Planning Application 20/02064/OUT

Strategic Growth Site North of Woodhouse Lane,
Broomfield

Representations of Broomfield Parish Council

12 February 2021

Broomfield Parish Council
Proposed Woodland Belt to south, west and north.
Linking Puddings Wood and Sparrowhawk Wood

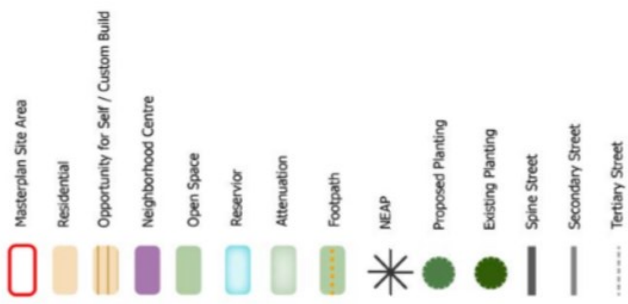
On the western edge of the SGS6, the woodland belt/green buffer would need to be 40-50 metres thick to provide cover in winter. For comparison, existing tree cover in Long Shapley Belt (southern edge of the Hospital site) is 20-30 metres thick and is insufficient to provide cover in winter, as the following photos show:

But these good intentions completely fail to materialize in the Indicative Masterplan diagram (page 31) and throughout the MFD generally. Boundary planting currently shown on the northern and western countryside edges appears patchy and completely insufficient to meet these requirements.

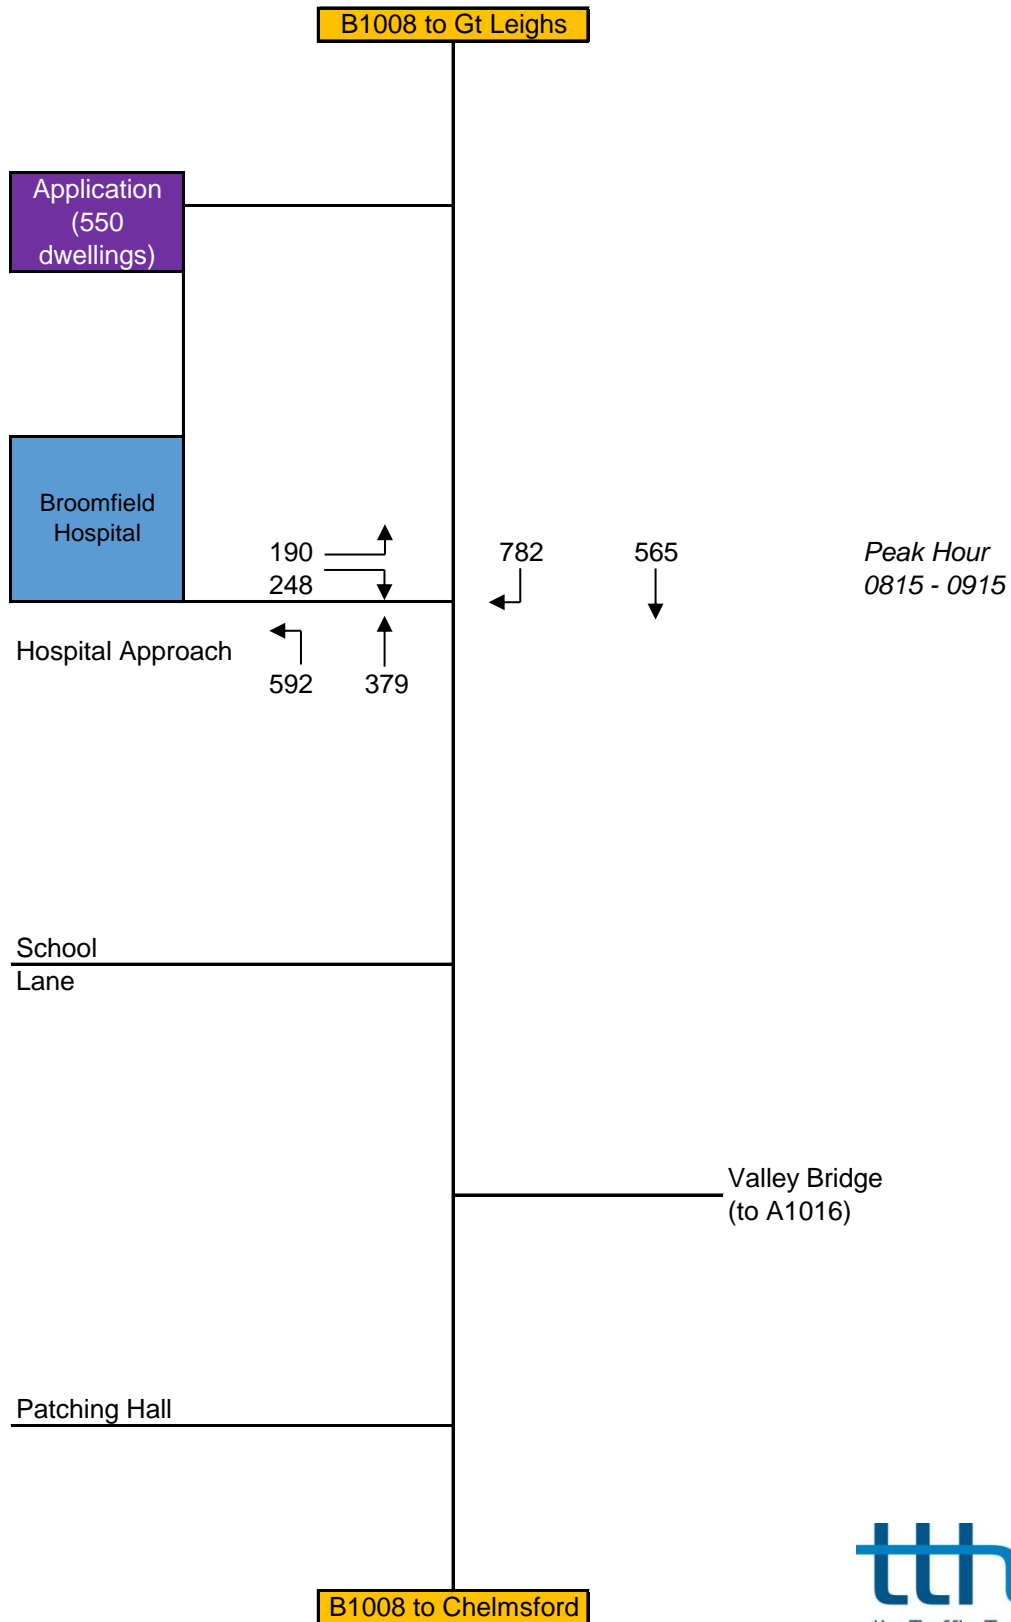
18. Regardless of the final form of the link road, there would still be a net increase on the B1008 corridor through Broomfield, between Hospital Approach and the city centre.
19. As shown in **Appendix A**, the majority of development traffic will route to and from the south on the B1008 corridor through Broomfield. The B1008 (Main Road) through Broomfield is a key bus corridor, with around 10 buses per hour in each direction. It is

also the emergency vehicle route between central Chelmsford and Broomfield Hospital.

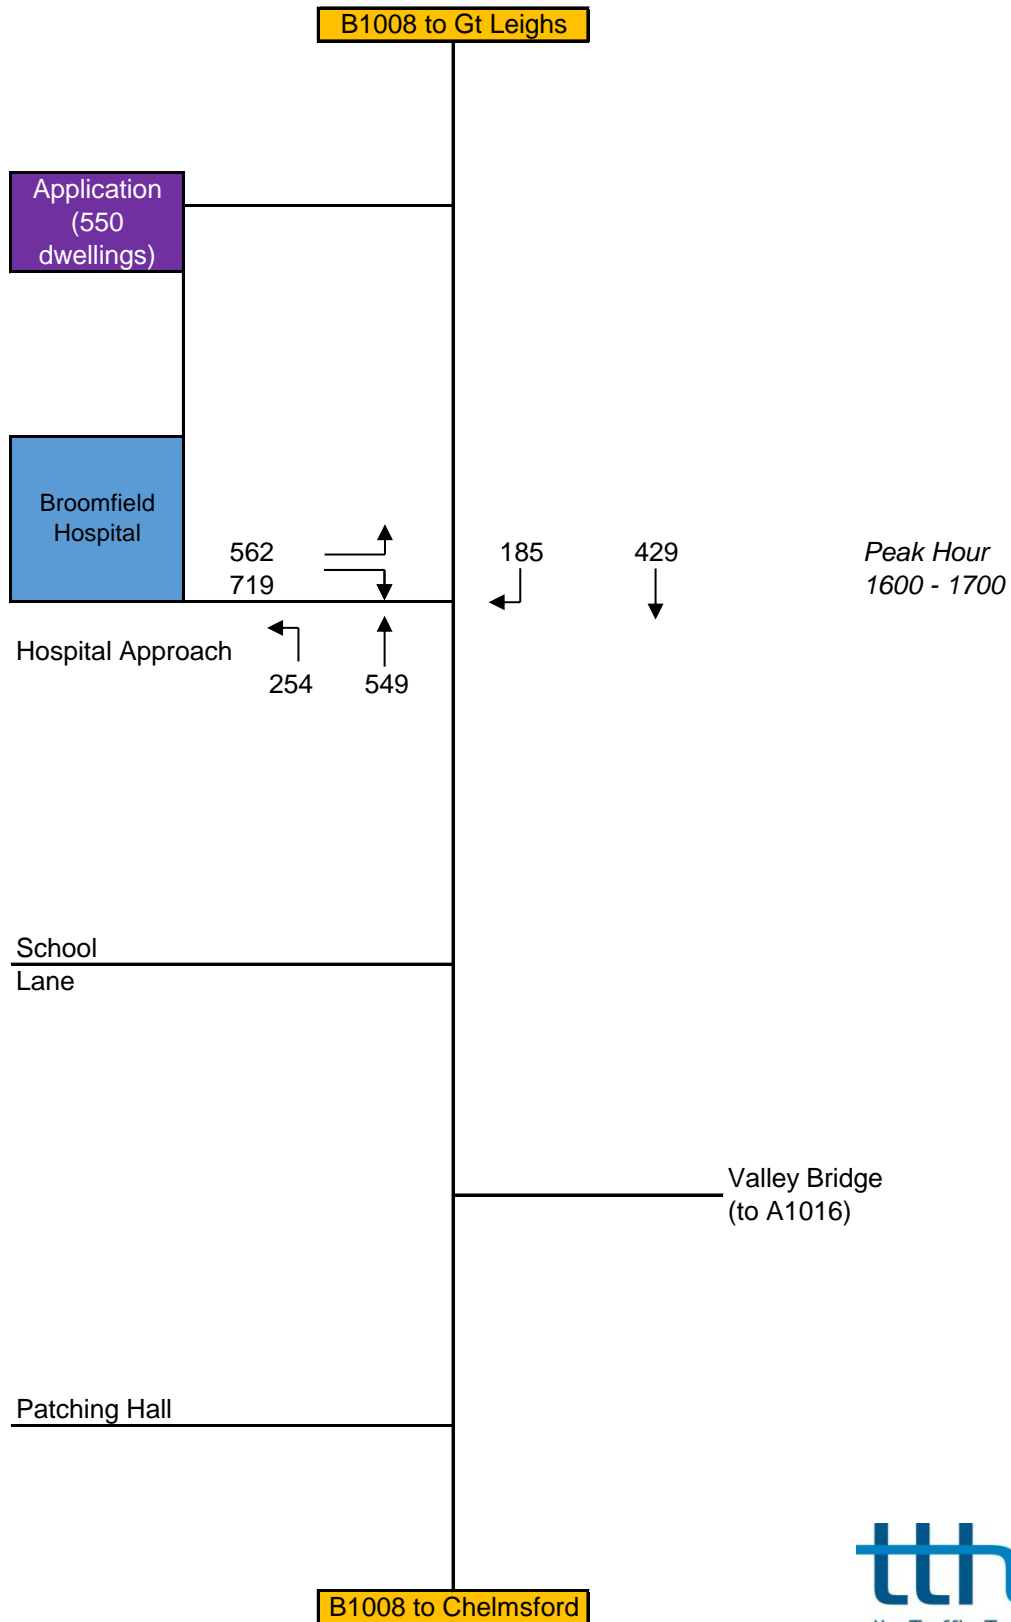
27. There is scope to introduce traffic light signals at the B1008 Main Road / School Lane junction, including a short flare on for vehicles turning right into School Lane. The pedestrian crossing further south could be relocated into this junction.

28. Although a signals arrangement would require a small amount of land from the village green to the west, this could be mitigated by stopping up the 'slip road' alongside Madelayne Court, and incorporating that land into a larger village green. As this is a registered village green, this would require the consent of the Parish Council and may need to follow a legal process.

29. The applicant should explore this option further. It would both reduce the forecast congestion at this junction, and improve bus journey times between the site and central Chelmsford.
